TECHNICAL STAFF REPORT Lawyers Hill Overlook

Planning Board Quasi-Judicial Public Hearing of June 6, 2019

PB Case No. 445 Lawyers Hill Overlook / Land Design and Development,

SP-19-002 Lawyers Hill Overlook, Lots 1-17 & Open Space Lot 18

FIRST ELECTION DISTRICT HOWARD COUNTY, MARYLAND SCALE: AS SHOWN DATE: MAY, 2019

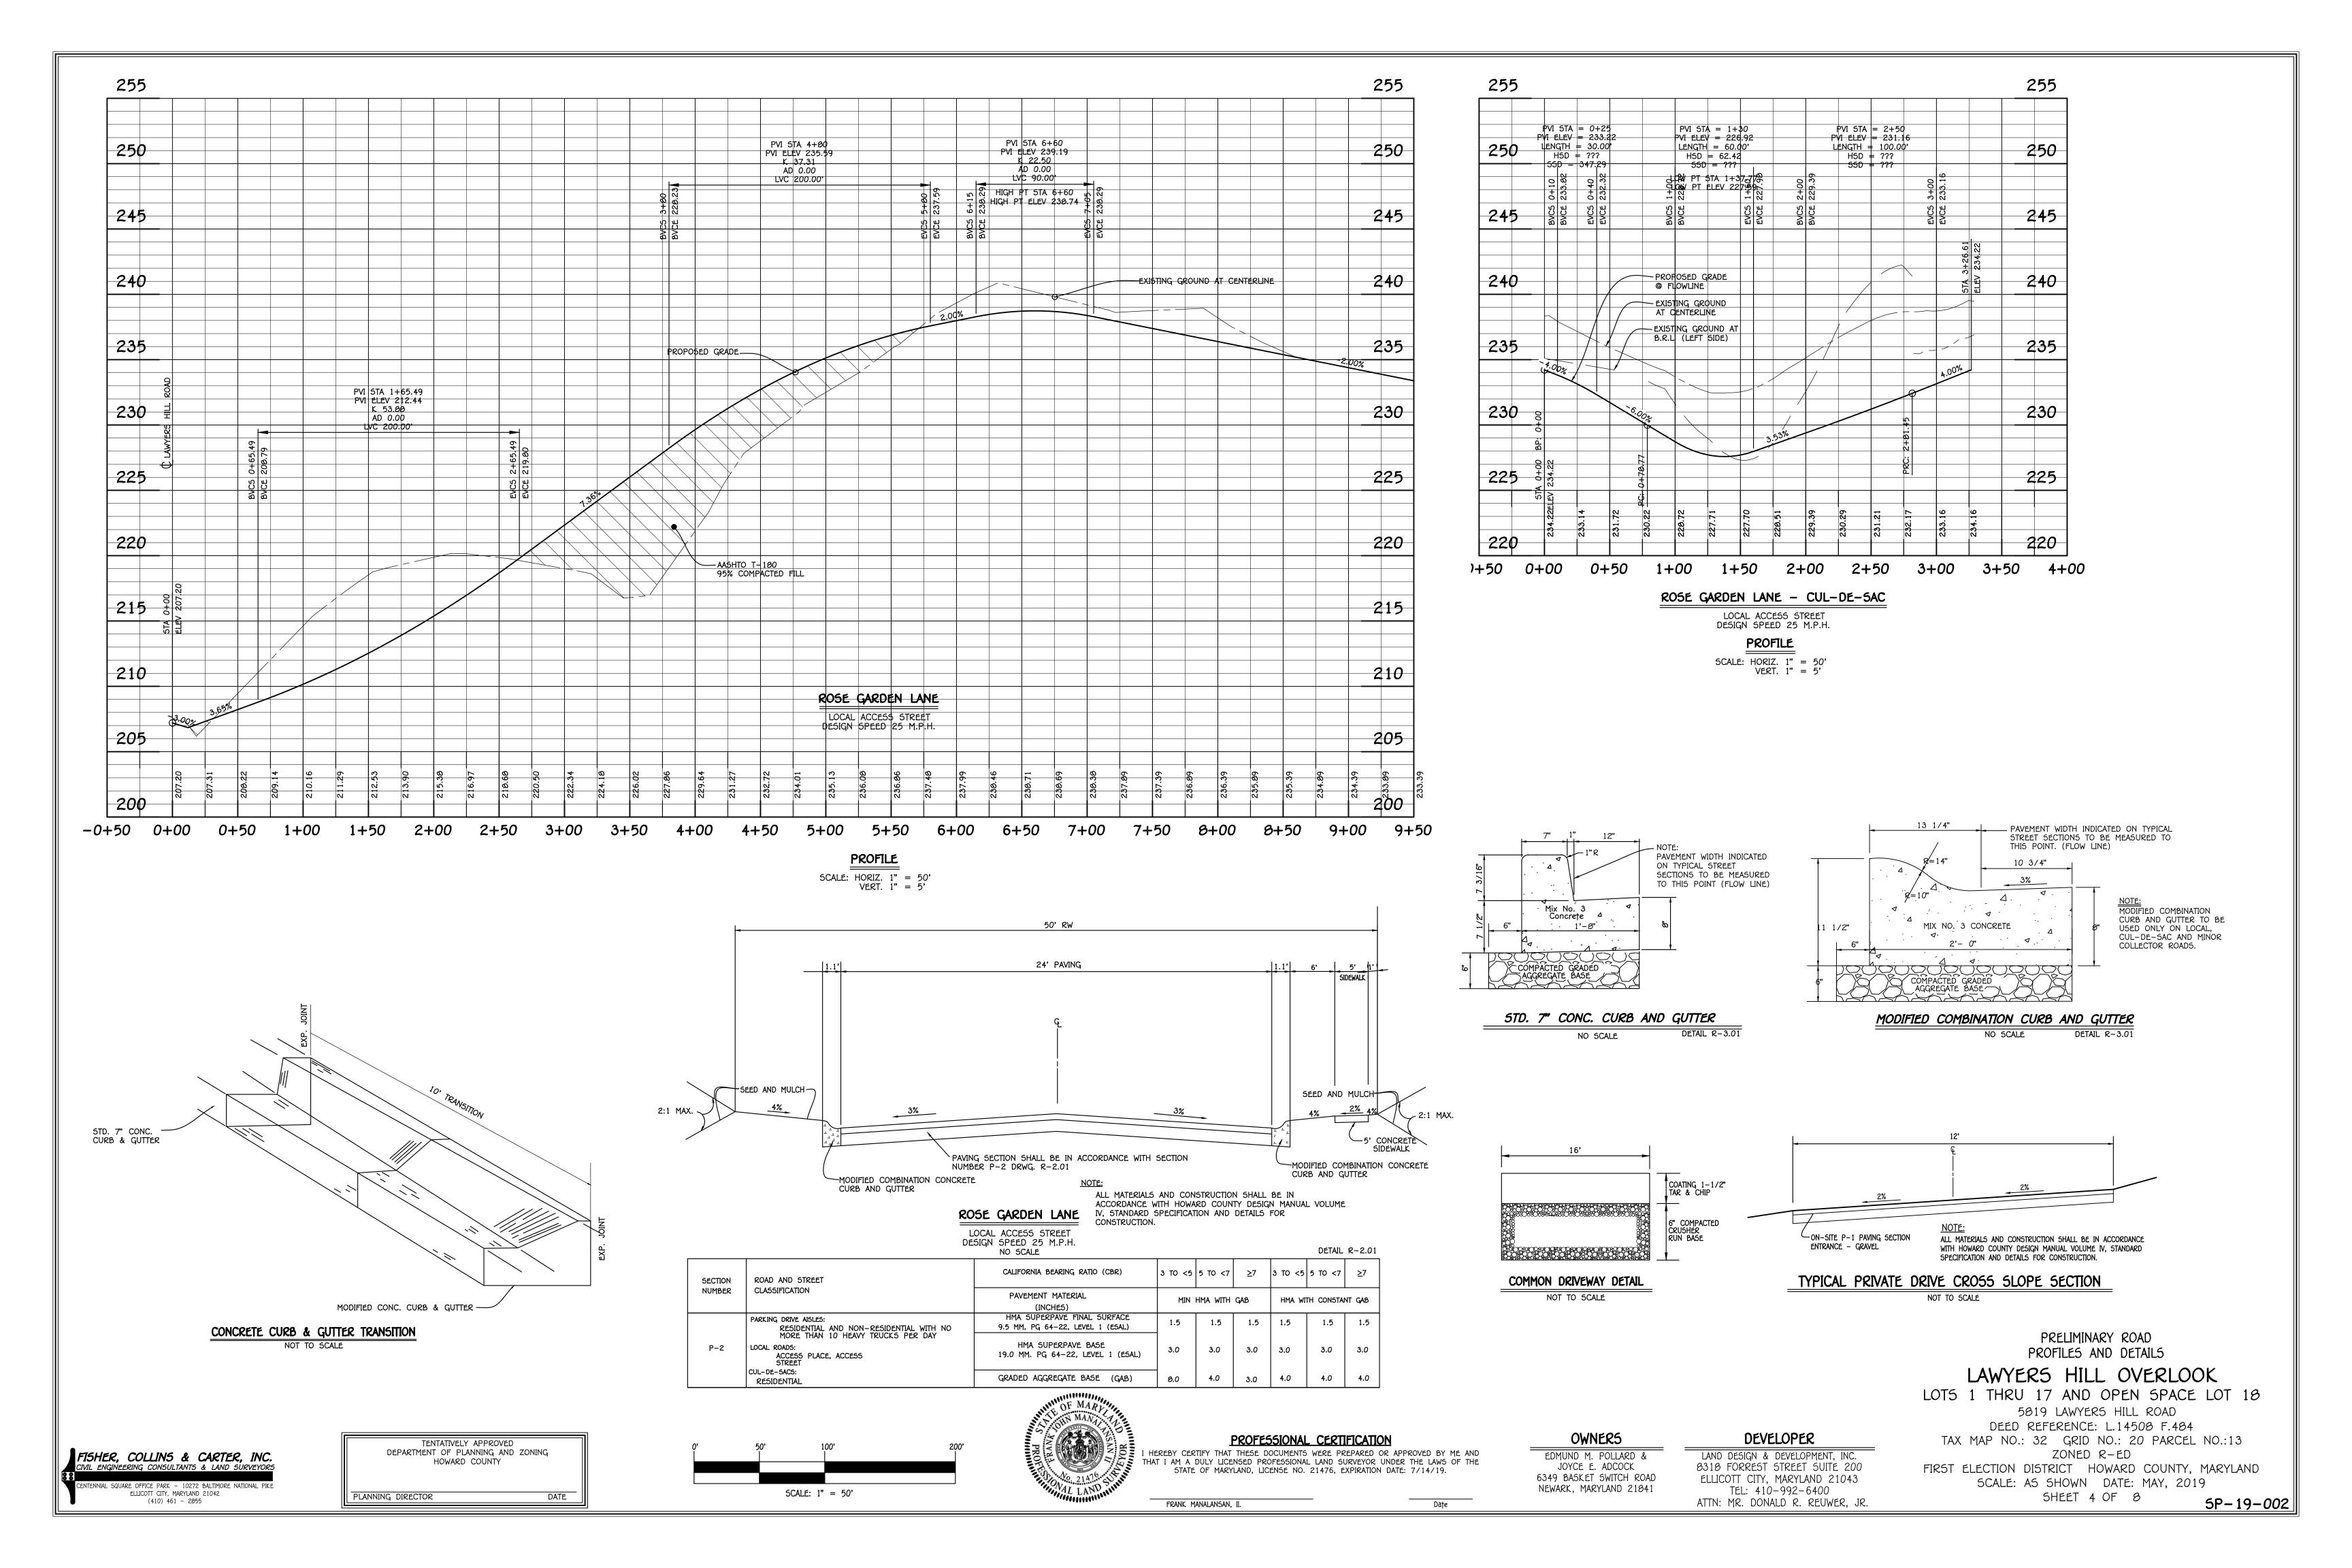
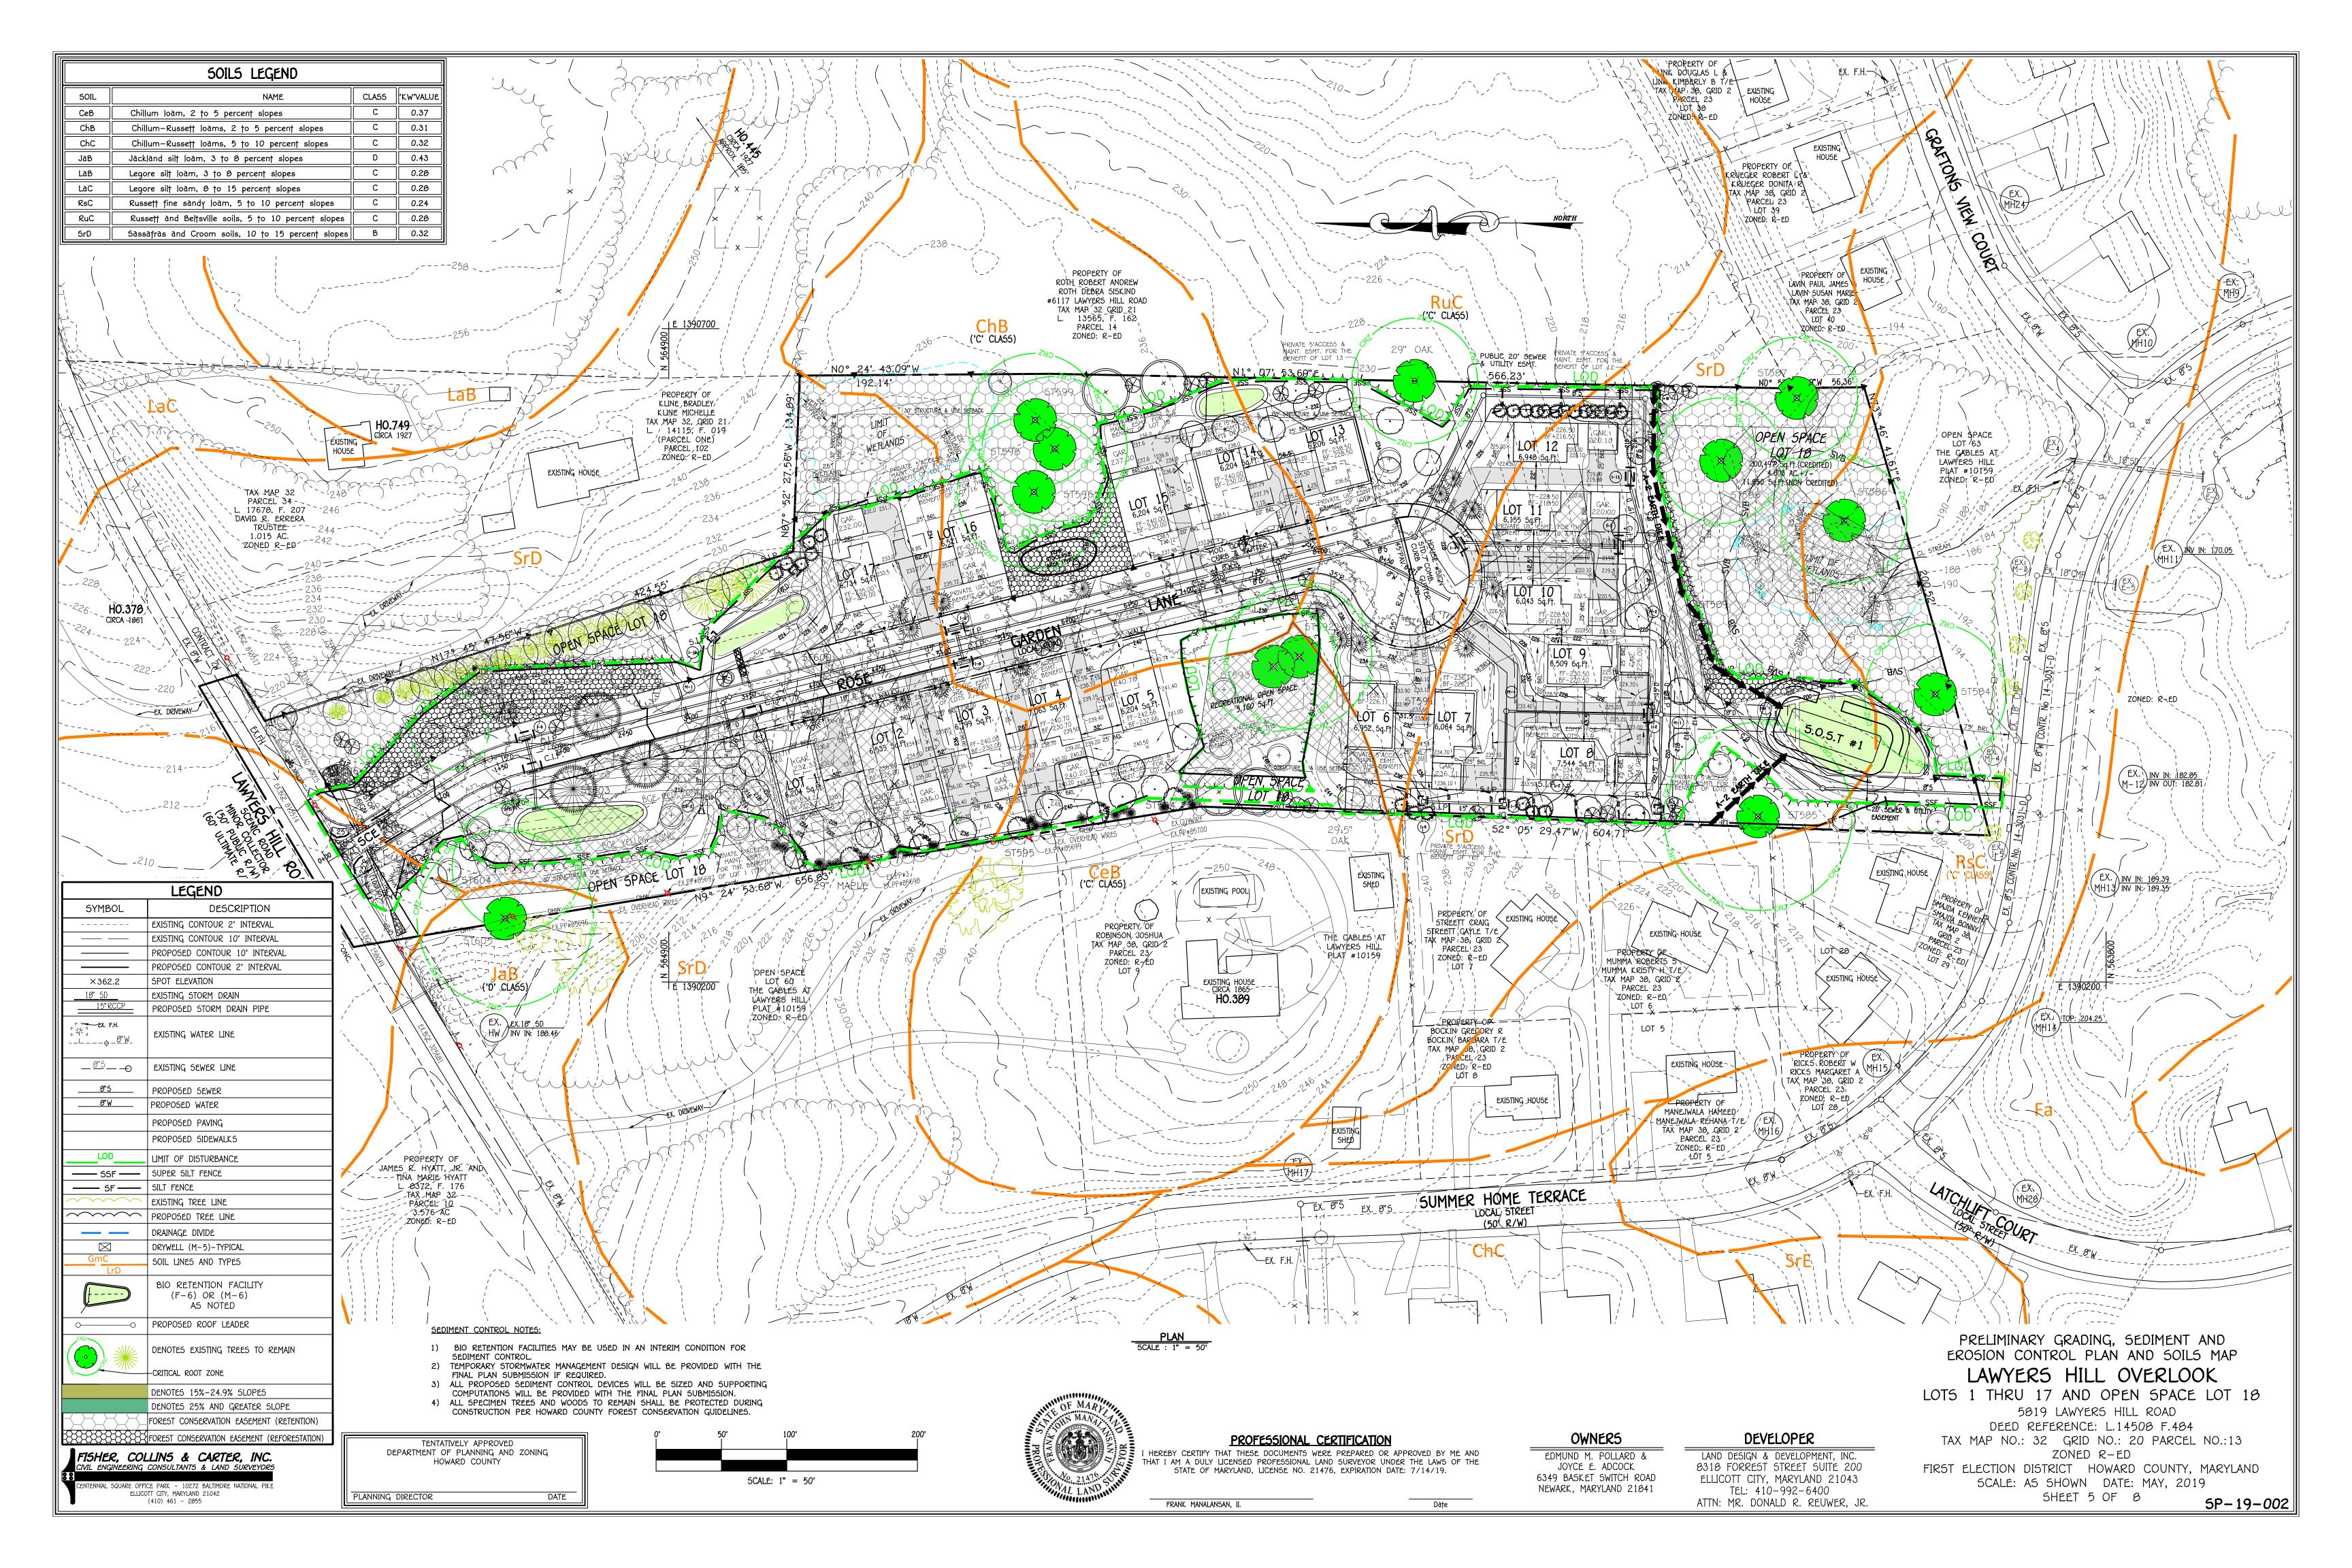
Mr. Reich stated that the plans showed a row of trees along the entry road and scattered deciduous trees around the perimeter of the houses. Mr. Reich asked which specimen trees were getting saved. Mr. Reich pointed to parts of the plan for Mr. Reuwer to confirm trees that were being saved. Mr. Reich asked about the evergreen trees on the plan. Mr. Reuwer stated those trees were being added and stated they were proposing to have trees to keep anyone who did not want to see the subdivision from seeing it. Mr. Reuwer said the stormwater management plan was tweaked so the evergreen trees by Ms. Kline's property would remain and not be removed. Mr. Reich stated it seemed on the south side by the Robinson house, the buffer was sparse. Mr. Reuwer said he was putting a thick buffer around the subdivision and was happy to have a thicker buffer in that open space. Mr. Reuwer stated he had a 30-foot setback that allowed for that.

Mr. Taylor asked if the specimen tree plan showed all of the trees. Mr. Reuwer said it did. Ms. Burgess clarified it showed all trees 30 inches in diameter or greater. Mr. Reuwer stated that was the definition of a specimen tree. Mr. Reich confirmed that there were 23 specimen trees on the specimen tree list and they matched the specimen trees shown on the plan. Mr. Shad confirmed that the plan and tree list matched.

Mr. Roth stated the preliminary sketch plan provided by the Applicant does not show either of the historic resources identified by the Commission in the advisory comments from April 2018. Mr. Roth advised that it should be revised before the Department of Planning and Zoning undertakes any further consideration of the proposal.

Mr. Roth stated the preliminary sketch plan provided by the Applicant does not show either of the historic resources identified by the Commission in the advisory comments from April 2018. Mr. Roth advised that it should be revised before the Department of Planning and Zoning undertakes any further consideration of the proposal.

- Relocated Open Space Lots to provide enhanced screening of the neighboring historic home known as The Gables (HO 389).
- Relocated several buildable lots to save more specimen trees.
- Modified the garage location to be either side loaded or detached and located behind the homes.
- Selected street tree species, location, and sizes to replicate the patterns found in the Lawyers Hill Historic District.
- Located the existing historic well house on a proposed Open Space Lot to help protect and buffer it.
